**Business Unit:** HARTING Electric

PI00000199-US

**Product Range:** Han-Modular®**Date:** 03/27/2025**Title:** PCN Han M12 Crimp Metal Nut

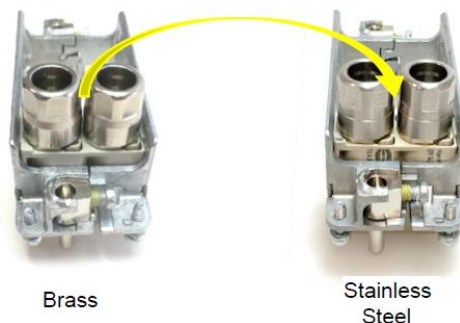
The outer diameter and material of the cable gland metal nut will be modified.

- Reduction of the nut outer diameter from 14.5 to 14.0 mm.
- Change of the material from brass, nickel plated to stainless steel without plating.

This improvement enables isolation between the two M12 connector shieldings such that there is no electrical contact. The gap between the nuts will be increased by 0.5 mm from 0.3 to 0.8 mm.
